Response to Reviewer 1

Response to Reviewer 2

Review of "Importance of ice elasticity in simulating tide-induced grounding line variations along prograde bed slopes" by Ross et al.

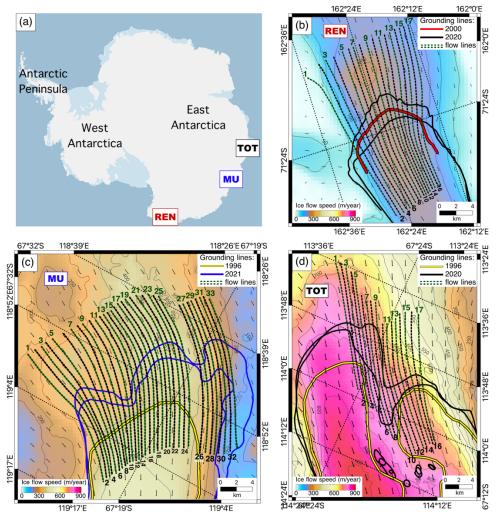
Figure 1: I find the geo-referenced figures a bit confusing. While I understand that the coordinates are expressed in polar stereographic, I wonder if these numbers may be difficult to interpret for readers who are not familiar with this reference system. Would it be possible to present the coordinates in latitude and longitude instead, as this might be a clearer choice? Additionally, I have some concerns about the rectangles in panel (a). I think they should be meant to represent the zoomed-in areas shown in the subsequent panels? It doesn't seem that they do.

Figure 2,3: Although the authors appear to be showing the same zoomed-in area as in Figure 1, the geometry seems distorted due to inconsistencies in the size of the inset boxes. For instance, panel (c) in Figure 1 is noticeably larger than panels (b) and (d), but this size disparity changes again in Figures 2 and 3. In my opinion, maintaining consistent sizing across all figures would help readers more easily recognize that the same area is being depicted throughout. Additionally, the comment I made regarding the coordinate labels in Figure 1 is also relevant to Figures 2 and 3.

We address the comments regarding the three figures collectively:

1) The projection used in all three figures is EPSG:3031, which defaults to meters as the unit. We believe that changing the default units from meters to degrees would be confusing for those familiar with this projection. However, we attempted to convert the coordinates from meters to latitude/longitude and found that it degraded the figure quality (see the modified Figure 1 below). In latitude/longitude coordinates, the grid becomes tilted, making the figure more difficult to interpret.

For the reasons listed above, we have opted not to modify the figures in the revised version of the manuscript.
